# Access Compliance Report Public Rights-of-Way (Curb Ramps)

Intersection ID: 26417	Main Street: BONNIE BUTLER_WY	Cross Street: RHETT BUTLER_PL	Location: SE
ADA ID: 4569BC8CE273	Ramp Type: Perp	Initial Pass/Fail: Fail	Overall Compliance: No Severity Score: 12.5

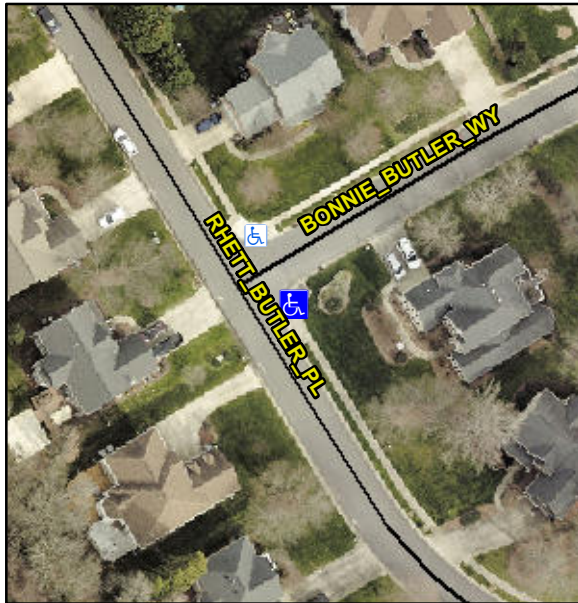
**Not Found, R304.2.2**

Compliance	Description	Data	Compliance	Description	Data
N/A	Ramp Length (in)	96.0	No	Ramp Slope (%)	10.2
Yes	Ramp Width (in)	48.0	Yes	Ramp XSlope (%)	0.5
N/A	Flare Type LT	N/A	N/A	Flare Type RT	N/A
N/A	Flare Slope LT (%)	N/A	N/A	Flare Slope RT (%)	N/A
N/A	Flare Traversable LT?	N/A	N/A	Flare Traversable RT?	N/A
N/A	Landing Length (in)	N/A	N/A	DWS Provided?	N/A
N/A	Landing Width (in)	N/A	N/A	DWS Contrast?	N/A
N/A	Landing Slope (%)	N/A	N/A	DWS Length (in)	N/A
N/A	Landing X Slope (%)	N/A	N/A	DWS Full Width?	N/A
N/A	Landing Curb? (Y/N)	N/A	N/A	DWS Offset (in)	N/A
N/A	Shared Landing?	N/A			
N/A	Gutter Ponding?	N/A	N/A	Gutter Slope (%)	N/A
N/A	Gutter Lip Ht (in)	N/A	N/A	Gutter X Slope (%)	N/A
N/A	Painted X Walk1?	No	N/A	Painted X Walk2?	N/A
	X Walk 1 Direction	To N		X Walk 2 Direction	N/A
N/A	X Walk 1 Width (in)	N/A	N/A	X Walk 2 Width (in)	N/A
	X Walk 1 Slope (%)	2.0		X Walk 2 Slope (%)	N/A
	X Walk 1 X Slope (%)	0.6		X Walk 2 X Slope (%)	N/A

**Remove & Replace Entire Ramp.**
